Source: T1
Title: CR's to TS 34.123-3 v.3.4.0, v.3.5.1 and v.3.5.2, TTCN category F
for approval
Agenda item: 5.1.3
Document for: Approval

This document contains the CR's to TS 34.123-3 v.3.4.0, v.3.5.1 and v.3.5.2, TTCN category F. These CRs have been agreed by T1 and are put forward to TSG T for approval.

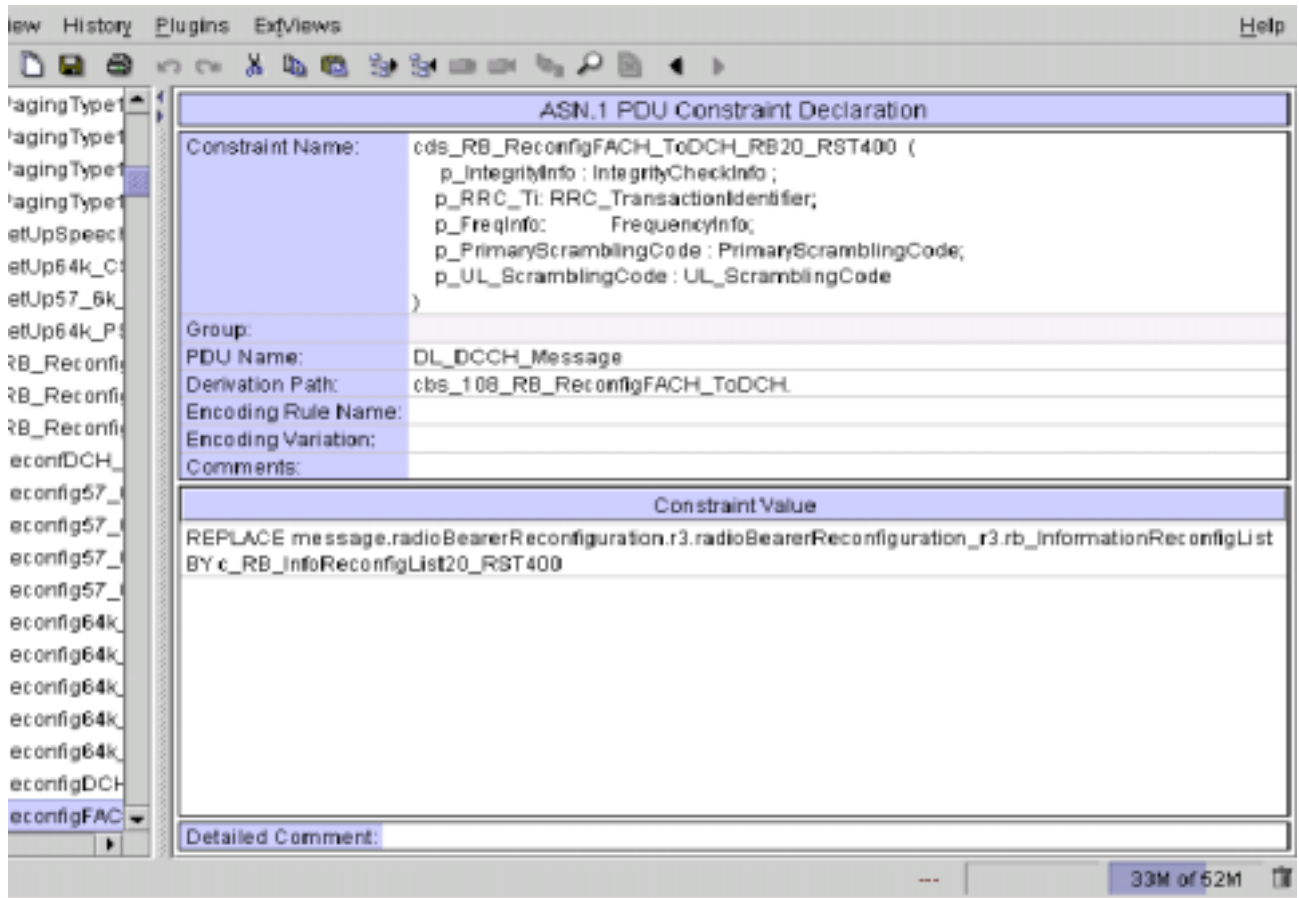
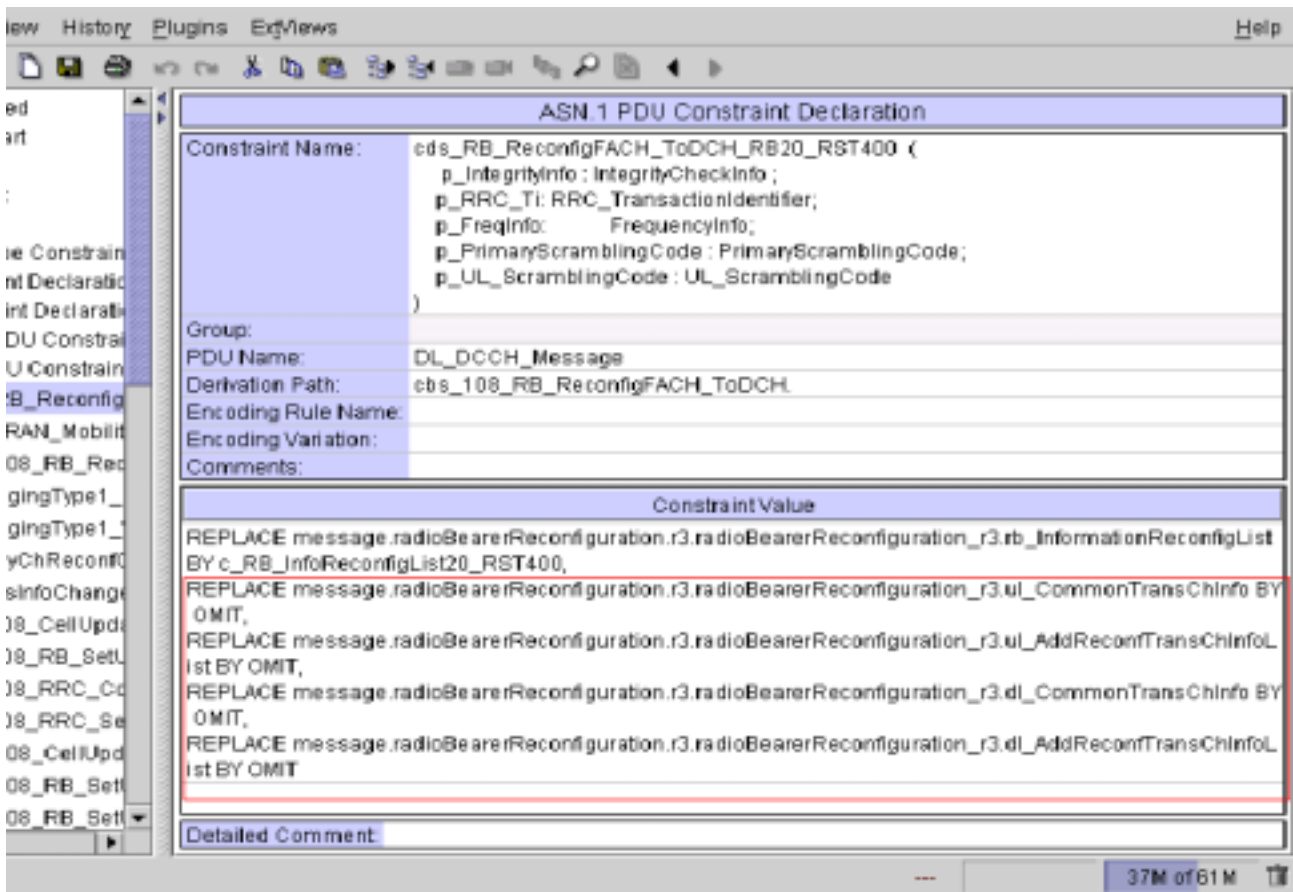
<p>But TTCN sends radio bearer reconfiguration message with the default value for these fields.</p>	UL Transport channel information for all transport channels	Not Present	Added or Reconfigured UL TrCH information	Not Present	DL Transport channel information common for all transport channels	Not Present	Added or Reconfigured DL TrCH information	Not Present
UL Transport channel information for all transport channels	Not Present								
Added or Reconfigured UL TrCH information	Not Present								
DL Transport channel information common for all transport channels	Not Present								
Added or Reconfigured DL TrCH information	Not Present								
Summary of change	Constraint cds_RB_ReconfigFACH_ToDCH_RB20_RST400 is modified to send radio bearer reconfiguration message which matches with the one given in 34.123-1								
Source of change	New change

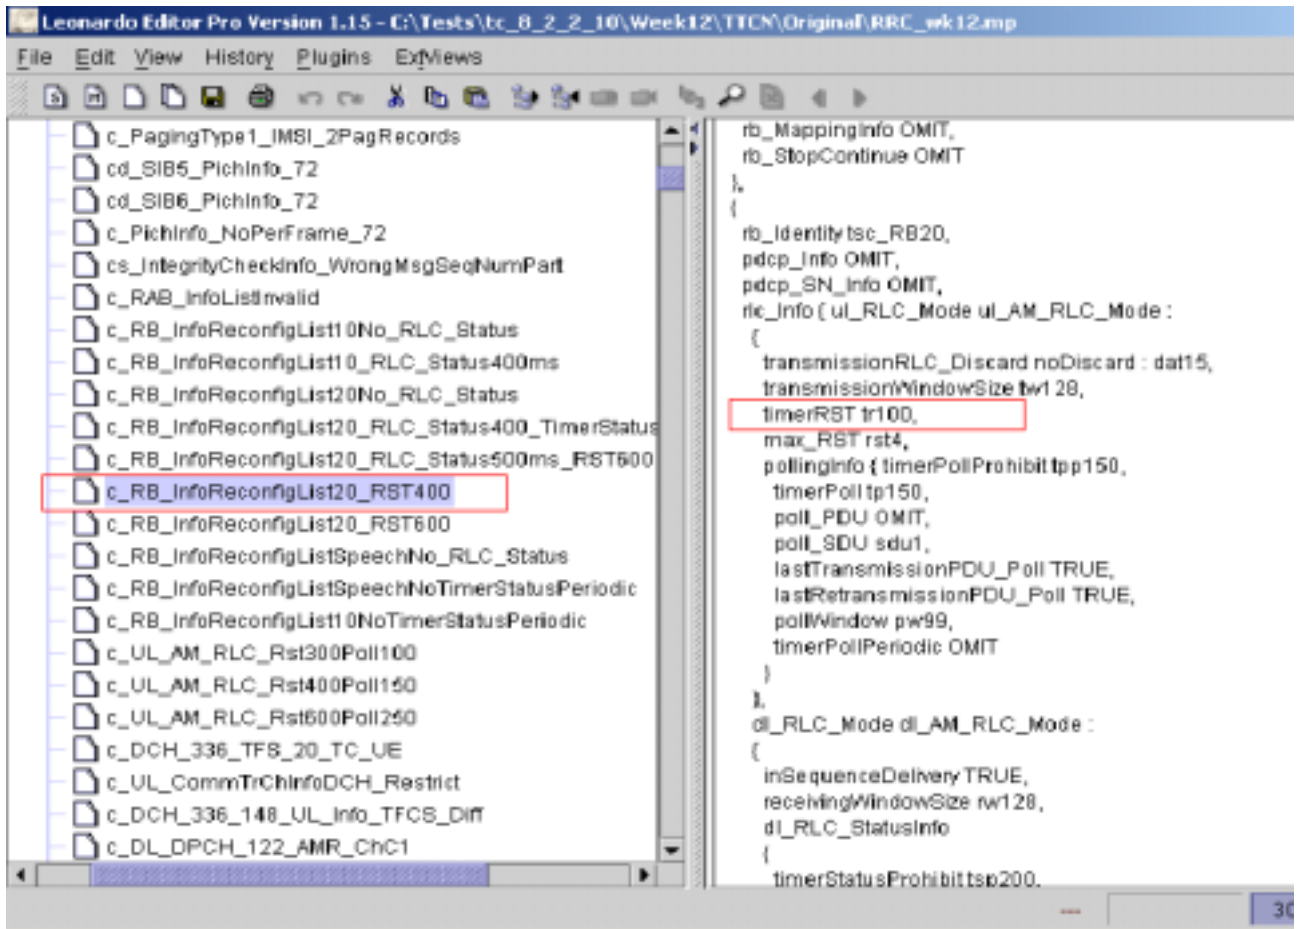
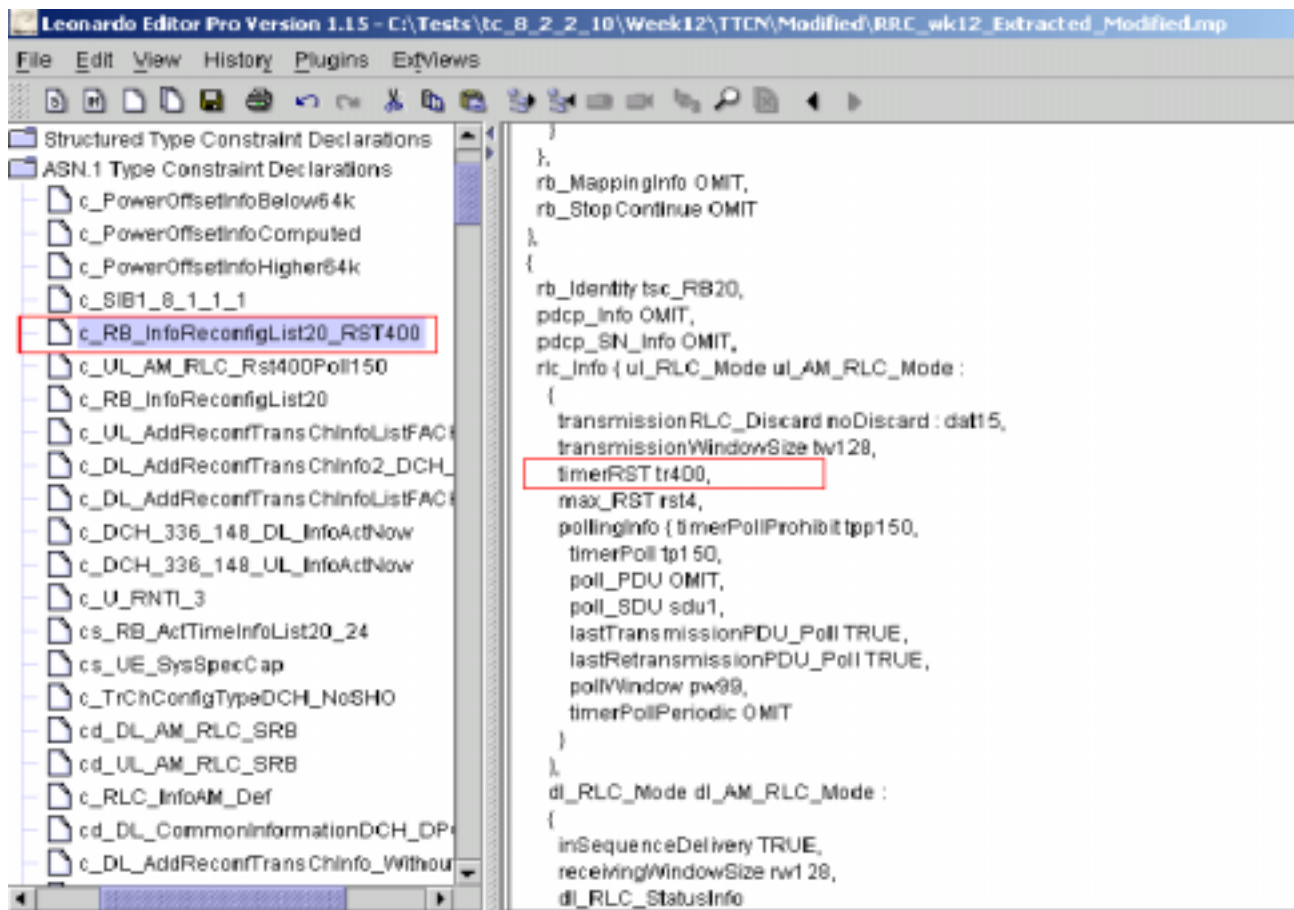
ASN.1 Type Constraint Declaration	c_RB_InfoReconfigList20_RST400
Reason for change	TS 34.123-1 specifies that in step 1 of test cases 8.2.2.10, for the radio bearer reconfiguration message, the value of field 'Timer_RST' which is the part of field 'RB information to reconfigure' for RB identity 20 should be 400. But the TTCN assigns value 100 to this field.
Summary of change	Constraint c_RB_InfoReconfigList20_RST400 is modified to make then field 'timerRST' of radio bearer identity tsc_RB20 set as tr400
Source of change	New change

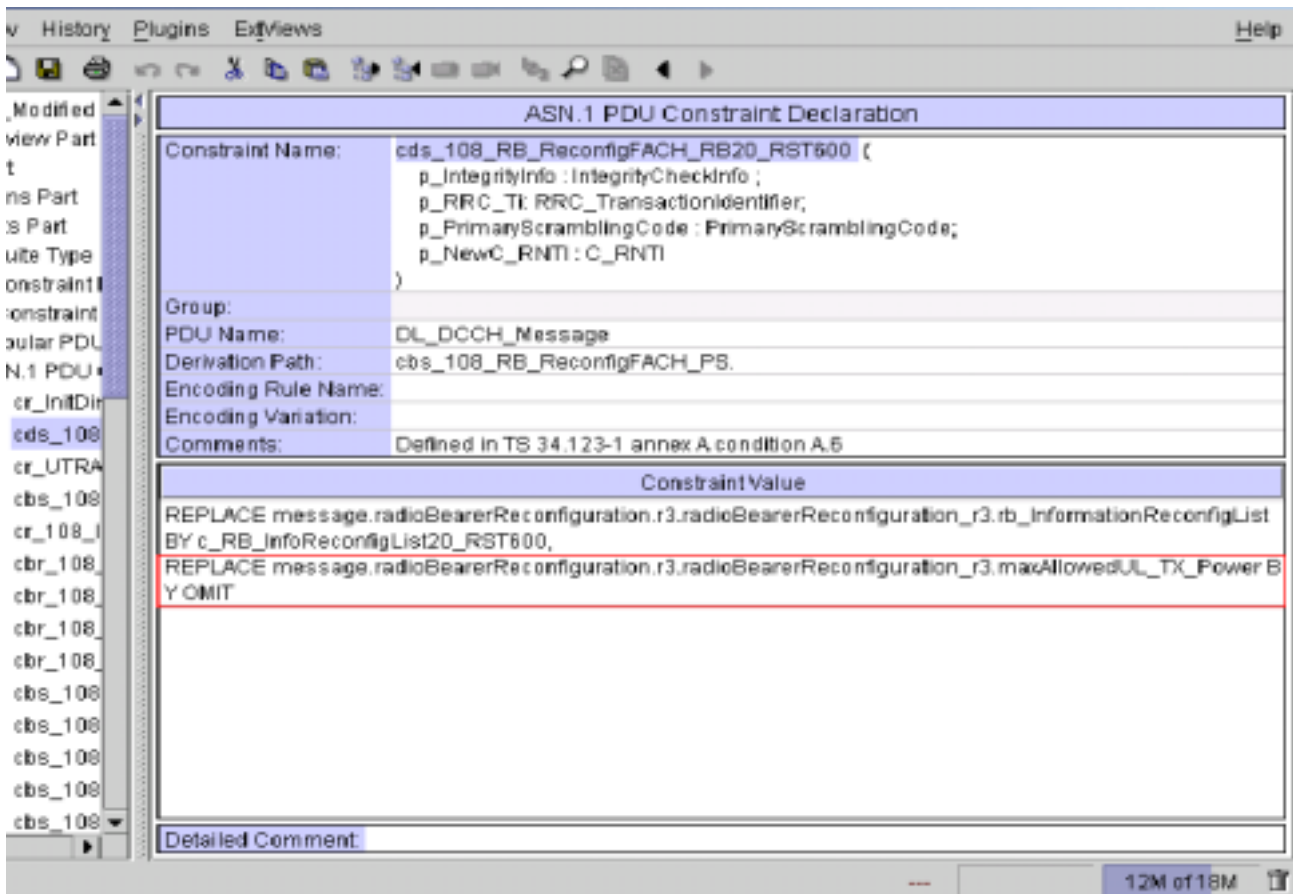
Constraint Value	
REPLACE message.radioBearerReconfiguration.r3.radioBearerReconfiguration_r3.rb_informationReconfigList BY c_RB_InfoReconfigList20_RST600

Change 2:

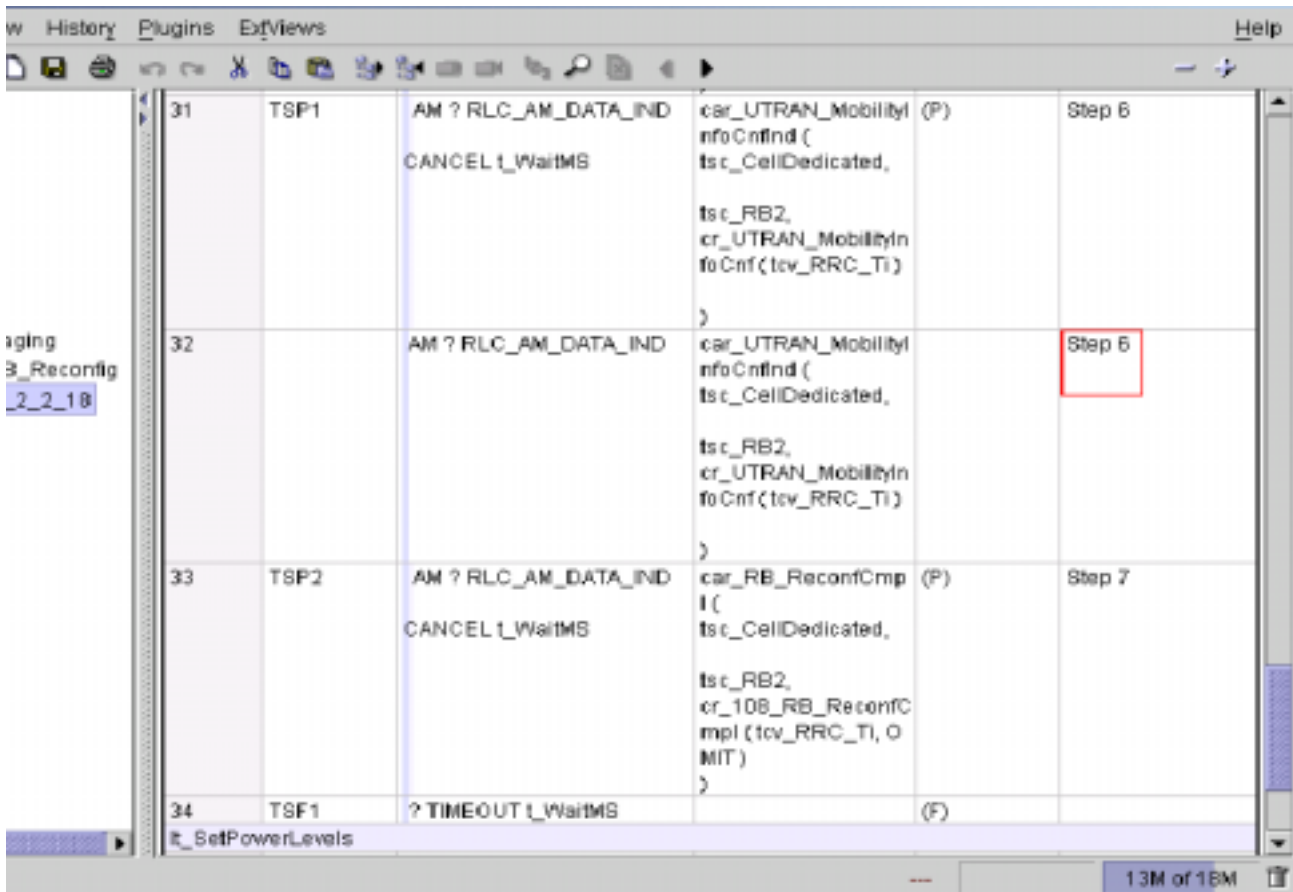
Step ID	Test Case Name	Test Data	Test Code	Step Name
31	TSP1	AM ? RLC_AM_DATA_IND CANCEL_t_WaitMS	car_UTRAN_MobilityInfoCnfnd (tsc_CellDedicated, tsc_RB2, cr_UTRAN_MobilityInfoCnf (tcv_RRC_Ti))	Step 6
32		AM ? RLC_AM_DATA_IND	car_UTRAN_MobilityInfoCnfnd (tsc_CellDedicated, tsc_RB2, cr_UTRAN_MobilityInfoCnf (tcv_RRC_Ti))	Step 5b
33	TSP2	AM ? RLC_AM_DATA_IND CANCEL_t_WaitMS	car_RB_ReconfCmpl (tsc_CellDedicated, tsc_RB2, cr_108_RB_ReconfCmpl (tcv_RRC_Ti, 0 MIT))	Step 6
34	TSP1	? TIMEOUT_t_WaitMS		(F)

Change 1:

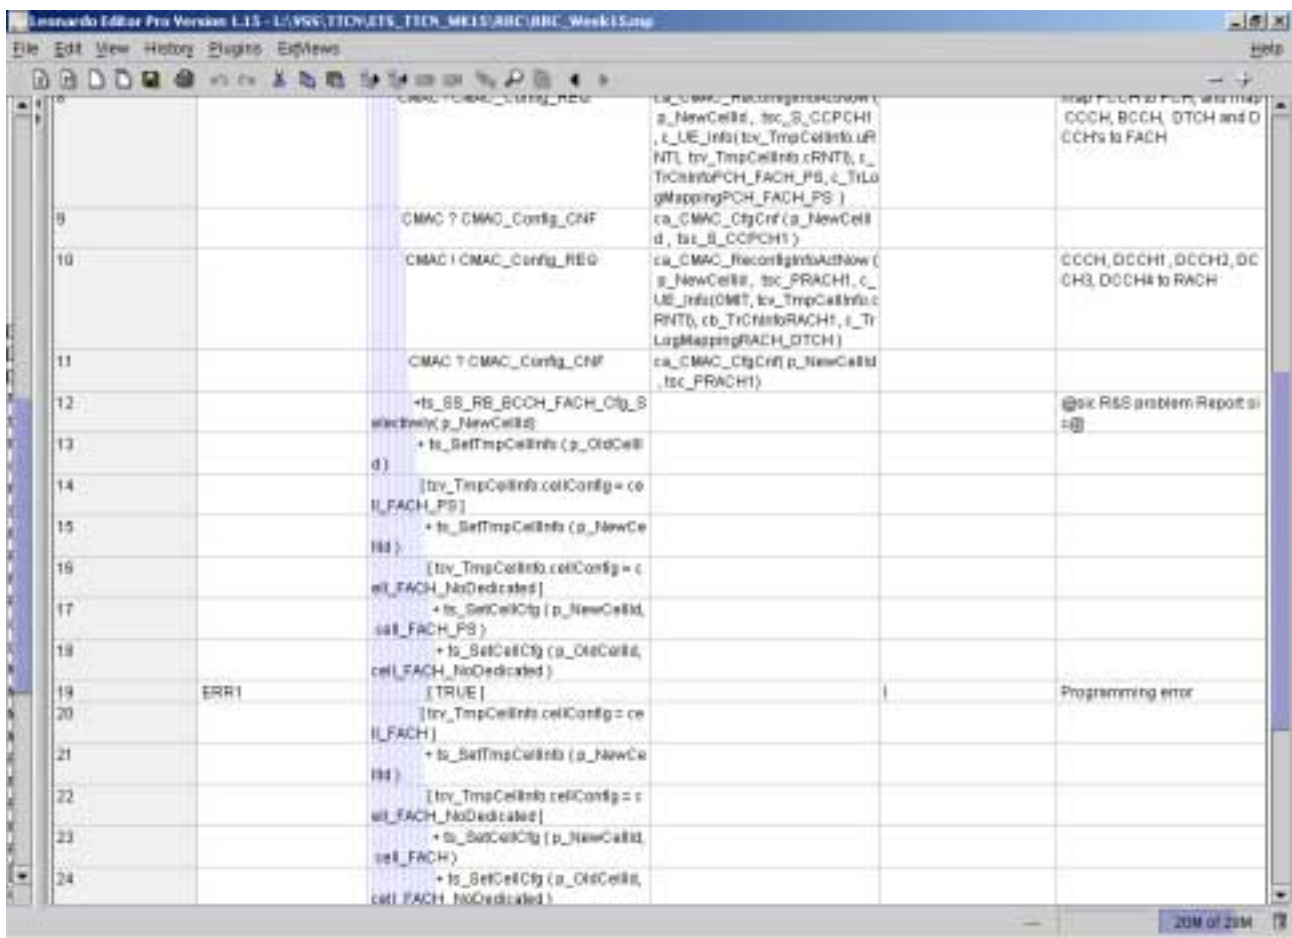
Local Tree and Test step	Test Step: ts_HO_ReconfFACH_ToFACH
Reason for change	RB_BCCH_FACH in the old cell should be deleted before the same is configured in the new cell.
Summary of change	Test Step 'ts_CRLC_Rel ' is called(#12) to delete the RB in the old cell
Source of change	New Change
